## Devlin Property

Re: Schematic Development Plan  
Devlin Property- 11506 Game Preserve Road  
RCI Job No. 1137B

Provided below are the responses to your comments dated May 28, 2014. The aforementioned comments are attached with this letter.

SDP-4560-2014

PRELIMINARY SUBDIVISION LOT PLAN

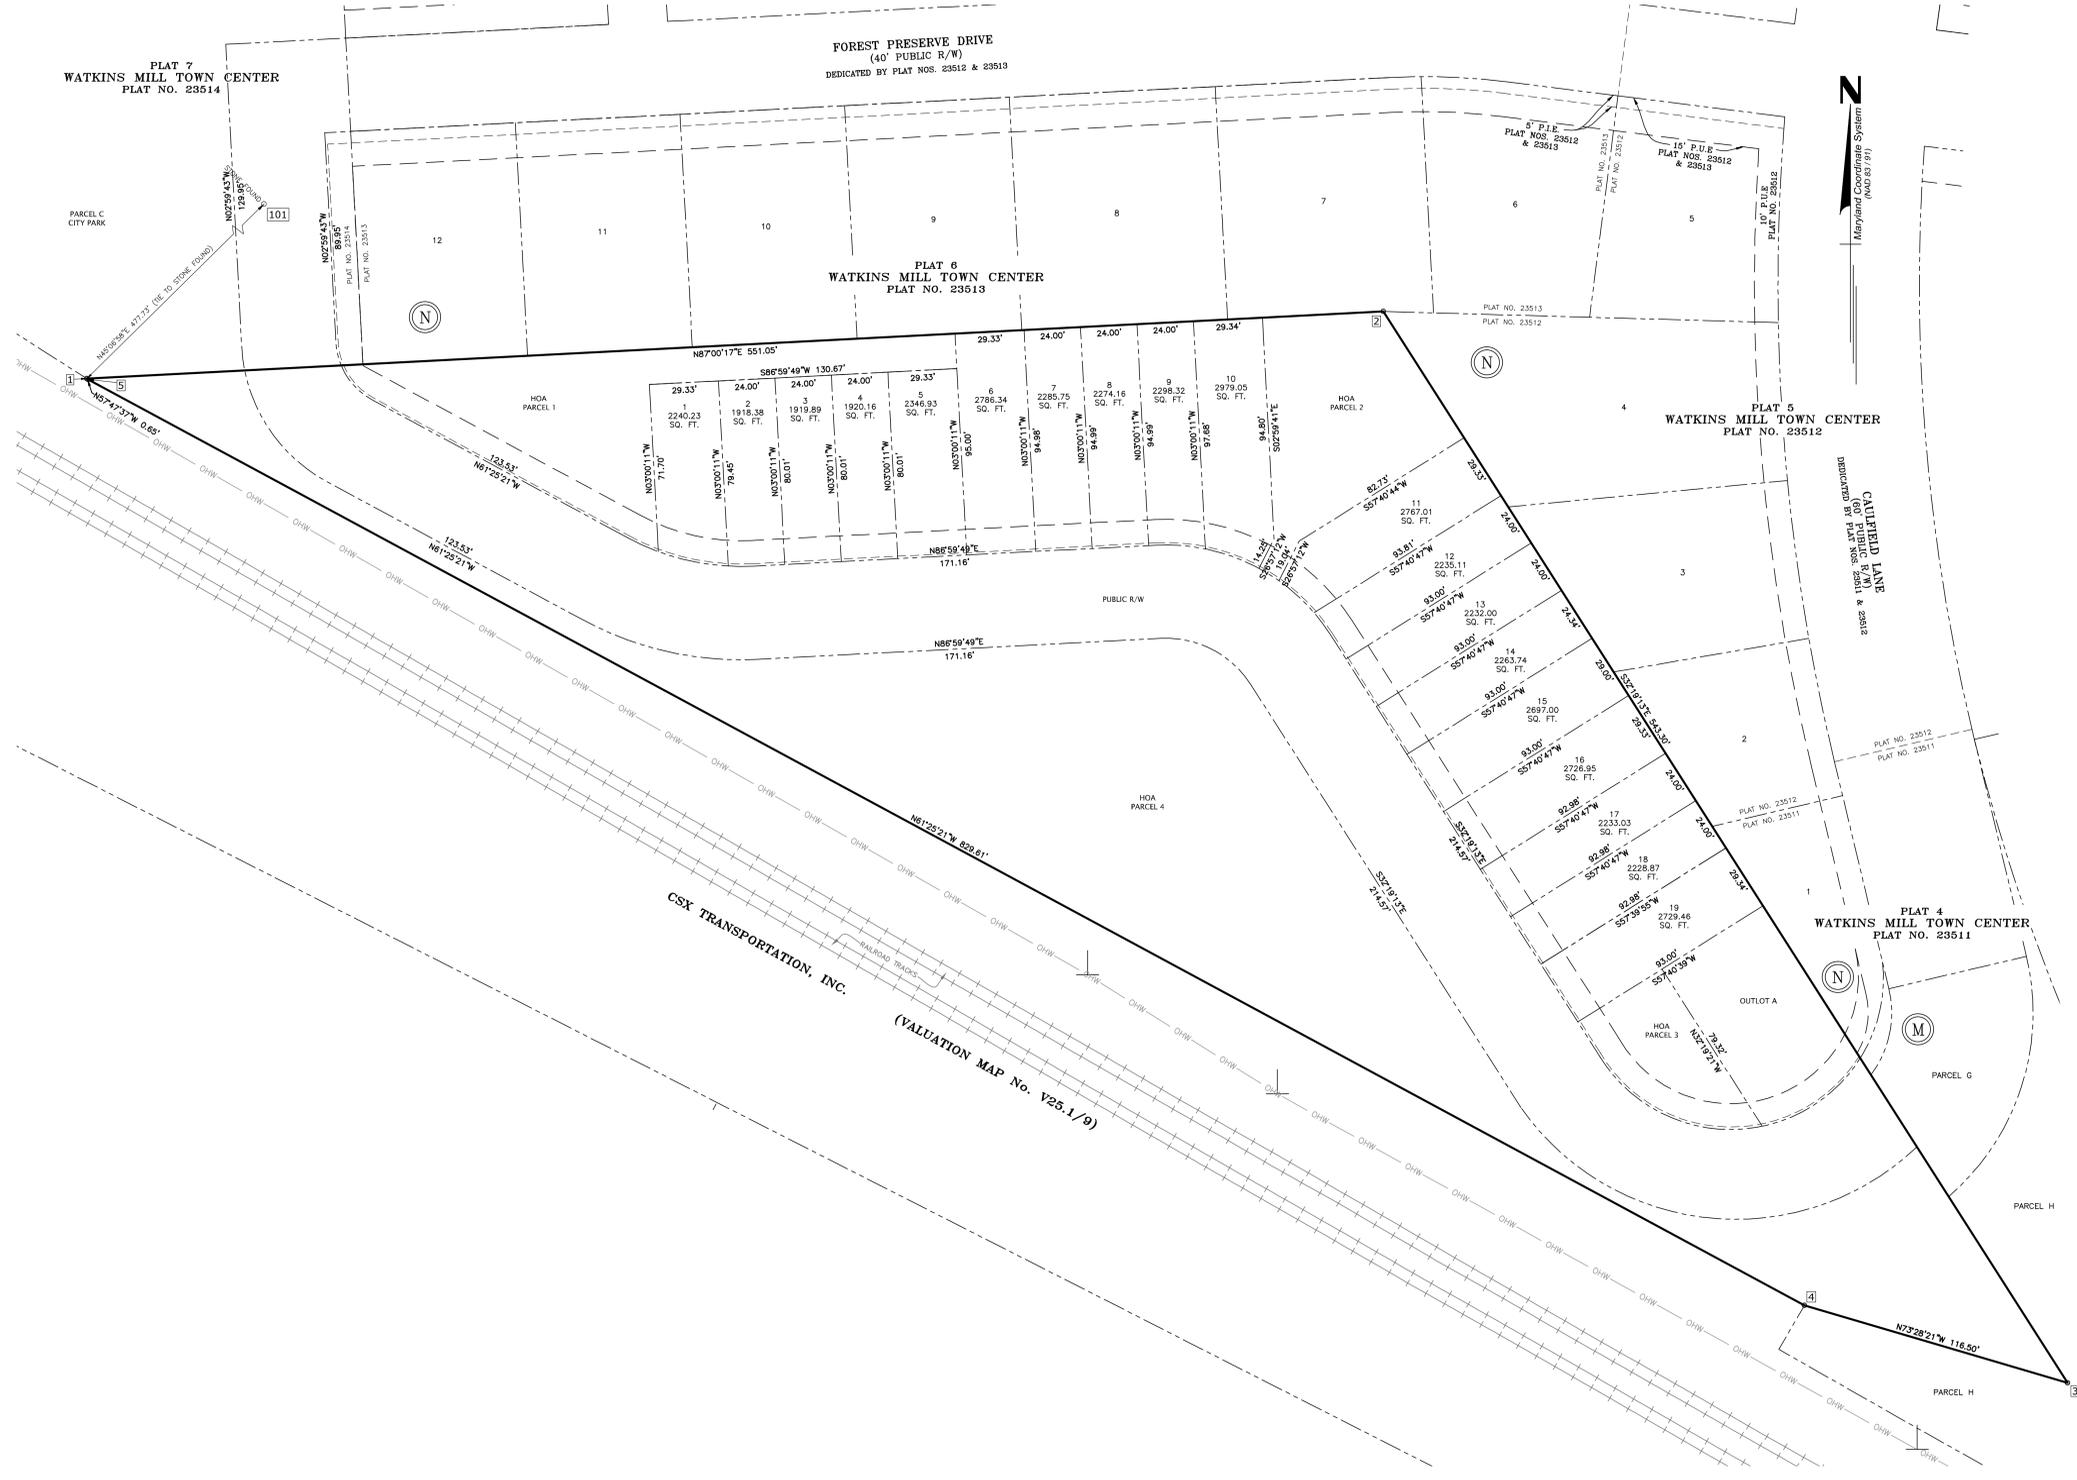
2. Please provide Preliminary Subdivision Lot Plan. Include the following on subdivision lot plan:
- Bearing and distances of lot lines
  - Square footage

**A Preliminary Subdivision Lot Plan is included in this submission, sheet 9.**
